## Austin Street Partners LLC c/o Dinosaur Capital Partners LLC 800 Boylston Street, 27<sup>th</sup> Floor Boston, MA 02199

Pursuant to Special Permit # 119-15, we hereby request a consistency ruling relative the following seven modifications we seek to make to the Approved Plans submitted with the above referenced Special Permit:

Figure 1.

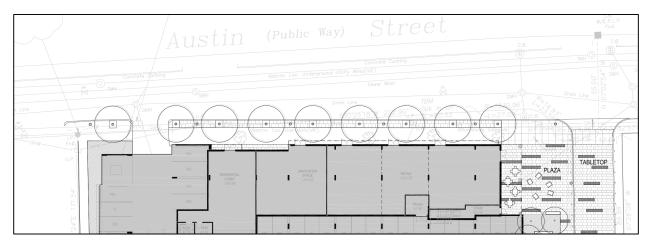
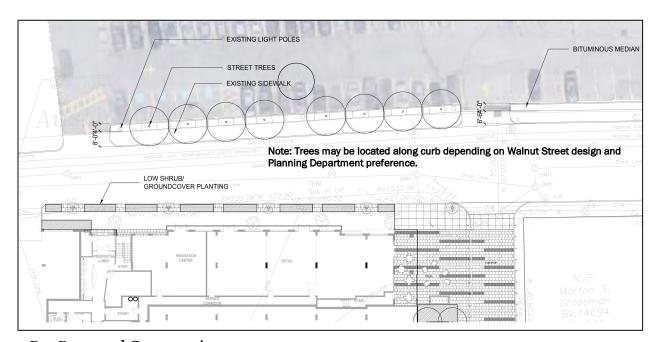
- 1. <u>Relocate nine street trees to avoid conflict with National Grid gas pipe.</u> Nine street trees that were to be planted along the south side of Austin Street in front of the building will be planted on the north (Star Market) side of Austin Street. This change is due to the discovery of the existence of a National Grid natural gas pipe which would interfere with planting. The number of trees as well as their size and specie will remain unchanged from the Approved Plans. Only the location will be changed. In addition, low plantings along the south side of Austin Street in lieu of trees will be substituted in front of the new building. *See Figure 1*.

Figure 2.

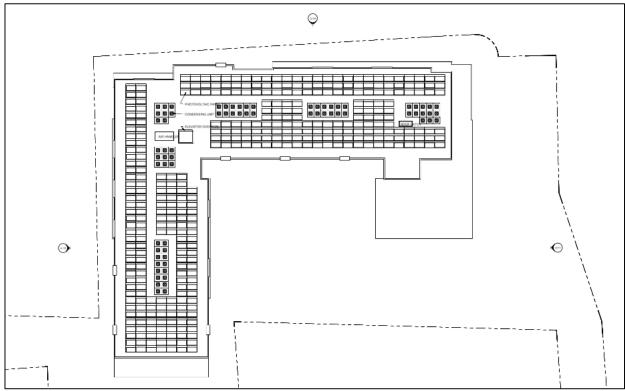
- 2. <u>Make roof solar ready rather install solar panels as solar may be economically infeasible due to changes in state subsidy</u>. Rooftop solar panels that were shown on the Approved Plans may not be included since the state's SREC subsidy program has ended possibly making solar panels economically infeasible. While we are still exploring alternatives and hopeful of finding an economic installation method, we seek the flexibility to design and construct the building and roof ready to accept solar panels should they become economically feasible in the future but not install them initially. See Figure 2.

<u>Figure 3.</u>

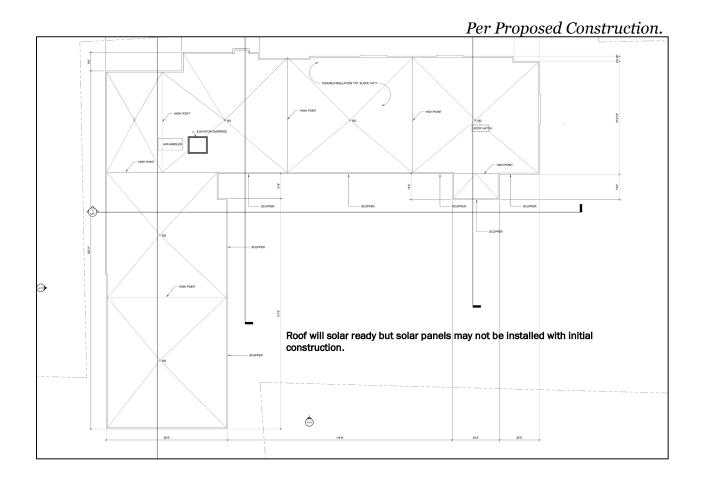
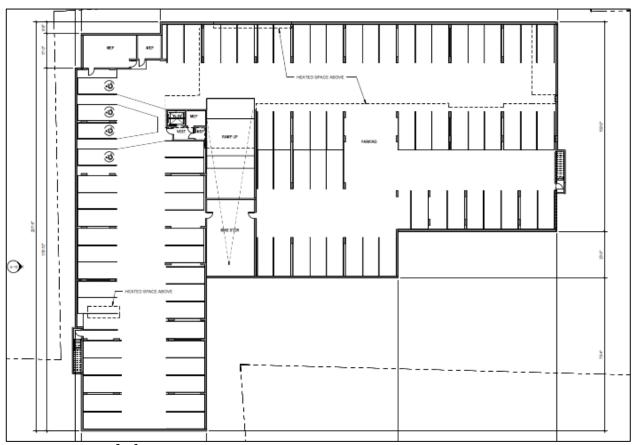
- 3. <u>Build a rectangular underground parking garage rather than an "L" shaped garage shown on Approved Plans.</u> Building a rectangular parking garage improves constructability and reduces construction time and disruption to municipal parking. There is no change to the required 90 parking spaces provided. *See Figure 3*.

## <u>Figure 4.</u>

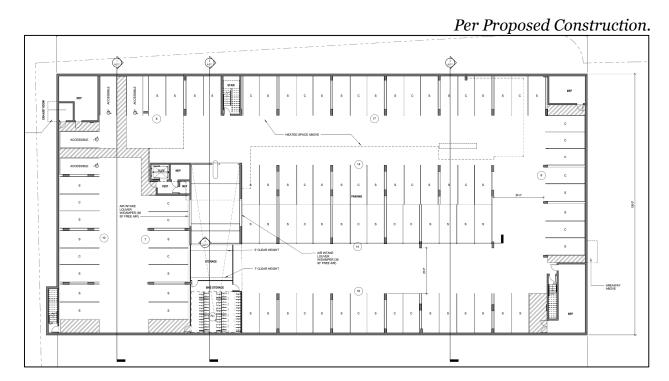
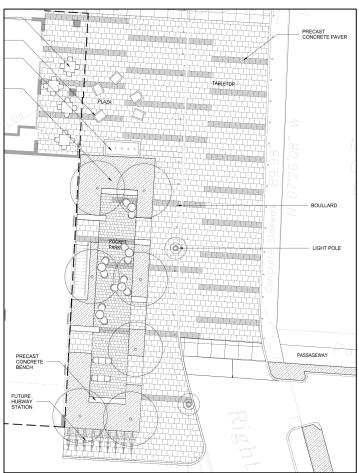
- 4. <u>Some trees in the public plaza may be relocated as the proposed rectangular garage extends under the plaza.</u> Planting trees on top of the concrete roof of the garage may prove problematic and require planter boxes or mounded beds. Alternatively, some trees may be relocated within the plaza area to allow them to be planted adjacent to rather than above the concrete garage roof to ensure their health and ability to thrive.

The number of trees as well as their size and specie will remain unchanged from the Approved Plans. Only the location will be changed. *See Figure 4*.

<u>Figure 5.</u>

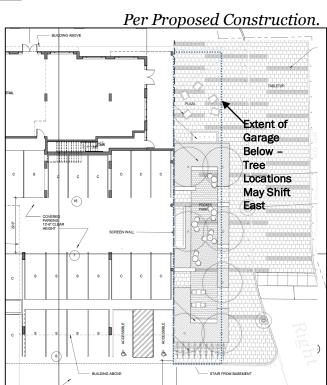
- 5. Three 6' arborvitae or comparable evergreen trees will be planted at the southern boundary as screening of the "12' Passageway" shown on the Approved Plans.

Austin Street Partners agreed to add three 6' arborvitae or comparable evergreen trees selected by the City of Newton Director of Urban Forestry as part of the settlement of litigation concerning issuance of the Special Permit. This will result in three additional trees on the site. See Figure 5.

Figure 6.

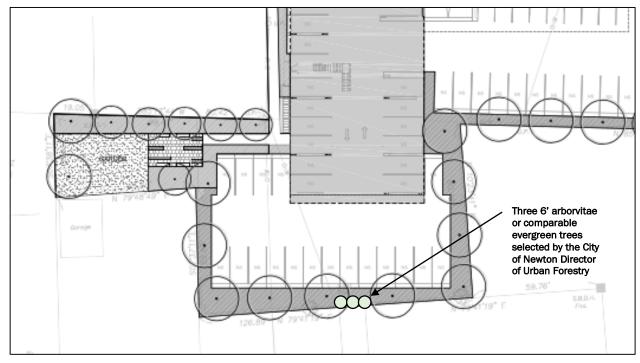
- 6. <u>The height of the building may exceed 48' by as much as 6".</u> Due to the need to accommodate a 12' tall fire truck under the building while maintaining adequate ceiling heights within the proposed apartments, the building may exceed the permitted height of 48' by up to 6" depending on structural system employed. *See Figure 6*.

Figure 7.

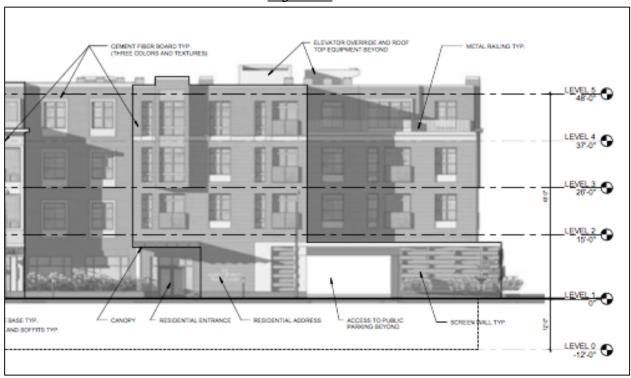
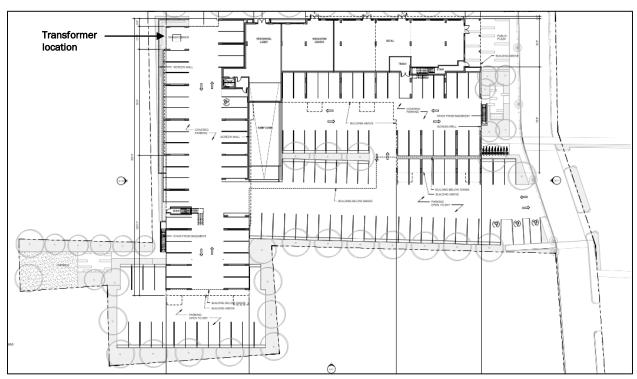
- 7. The electrical transformer must be relocated from the northwest corner of the site to the southeast corner of the site pursuant to new requirements from Eversource, the electric utility. Eversource has decided that they prefer and require the new transformer to be moved from the previously proposed location under the building in the northeast corner of the site to an open location in the southeast corner of the parking lot. The transformer will be screened with plantings and there will be no change in the number of parking spaces. See Figure 7.
